# DEVELOPMENT REVIEW COMMITTEE MEETING AGENDA

## PROJECT - FPL SURFACE PARKING LOT

#### **Re: The Florida Power and Light (FPL) Surface Parking Site Plan Amendment Development Review Committee Comments**

**Re: FPL Juno Beach Campus  
Review of Environmental Impacts in Application for Site Plan Amendment dated 3/2/2026  
WGI Project # 11021.02**

**APPENDIX 1**  
**SITE PRESERVATION PLAN**

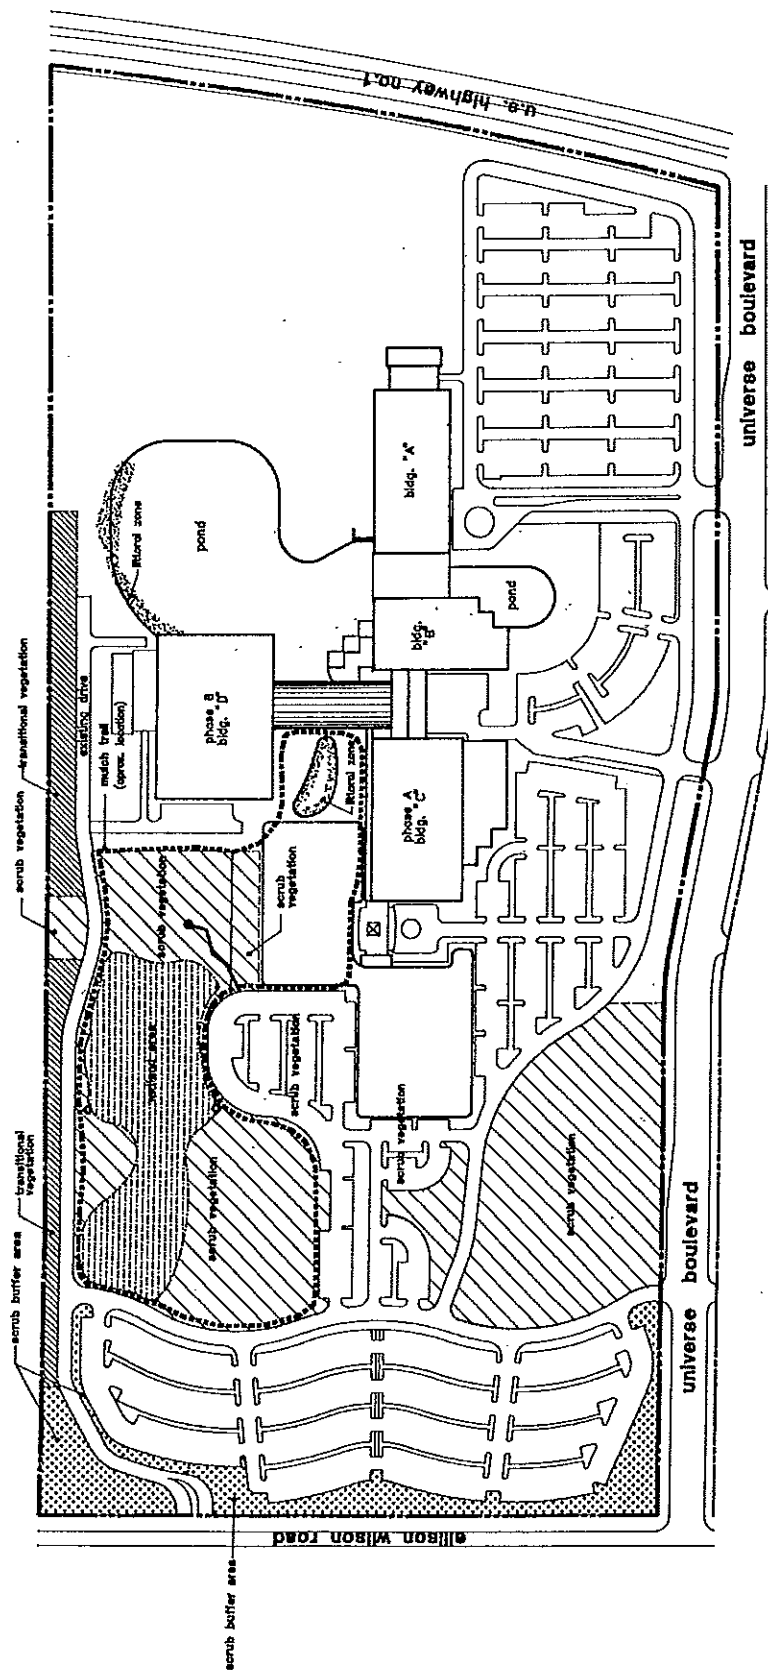
2. Condition of Development Approval #4 requires a Preserve Area Management Plan (PAMP) that describes the preserved native habitat identified on the property. The PAMP was approved by the Town of Juno Beach in January 1993. Map A of this PAMP is a Site Preservation Plan which was itself modified in 2014 to accommodate the construction of the parking garage on the west. The submitted Habitat

Assessment Report (prepared by EAI and dated February 2026) appears to closely align with the preserved areas outlined in the 2014 Site Preservation Plan. We recommend that the applicant provide an updated Site Preservation Plan that accounts for the proposed improvements to the property while maintaining a minimum of 10.5 acres of upland habitat and a minimum of 2.0 acres of wetland habitat or in the case that the condition of development approval #4 is modified to reduce the acreage that a new site preservation plan be produced to show the revised acreages.
